# Access Compliance Report

## Public Rights-of-Way

### (Curb Ramps)

Intersection ID: 14401	Main Street: BAXTER_ST	Cross Street: BALDWIN_AV	Location:	N
ADA ID: BBF33B27B14B	Ramp Type: PerpDiag	Initial Pass/Fail: Fail	Overall Compliance: No	Severity Score: 12.5

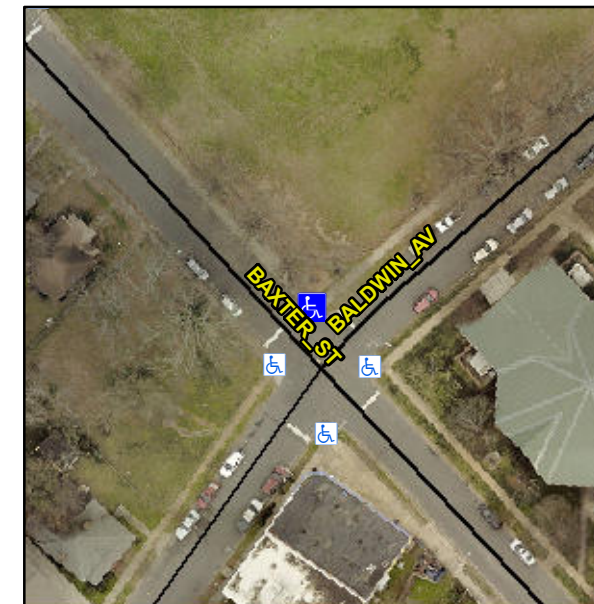
**R304.2.2**

Compliance	Description	Data	Compliance	Description	Data
N/A	Ramp Length (in)	87.0	No	Ramp Slope (%)	10.7
Yes	Ramp Width (in)	48.0	Yes	Ramp XSlope (%)	1.9
N/A	Flare Type LT	N/A	N/A	Flare Type RT	N/A
N/A	Flare Slope LT (%)	N/A	N/A	Flare Slope RT (%)	N/A
N/A	Flare Traversable LT?	N/A	N/A	Flare Traversable RT?	N/A
N/A	Landing Length (in)	N/A	N/A	DWS Provided?	N/A
N/A	Landing Width (in)	N/A	N/A	DWS Contrast?	N/A
N/A	Landing Slope (%)	N/A	N/A	DWS Length (in)	N/A
N/A	Landing X Slope (%)	N/A	N/A	DWS Full Width?	N/A
N/A	Landing Curb? (Y/N)	N/A	N/A	DWS Offset (in)	N/A
N/A	Shared Landing?	N/A			
N/A	Gutter Ponding?	N/A	N/A	Gutter Slope (%)	N/A
N/A	Gutter Lip Ht (in)	N/A	N/A	Gutter X Slope (%)	N/A
N/A	Painted X Walk1?	No	N/A	Painted X Walk2?	No
	X Walk 1 Direction	To SW		X Walk 2 Direction	To SE
N/A	X Walk 1 Width (in)	N/A	N/A	X Walk 2 Width (in)	N/A
	X Walk 1 Slope (%)	3.7		X Walk 2 Slope (%)	4.6
	X Walk 1 X Slope (%)	1.6		X Walk 2 X Slope (%)	0.6

**Remove & Replace Curb Ramp With Two New Directional Ramps or Equivalent.**
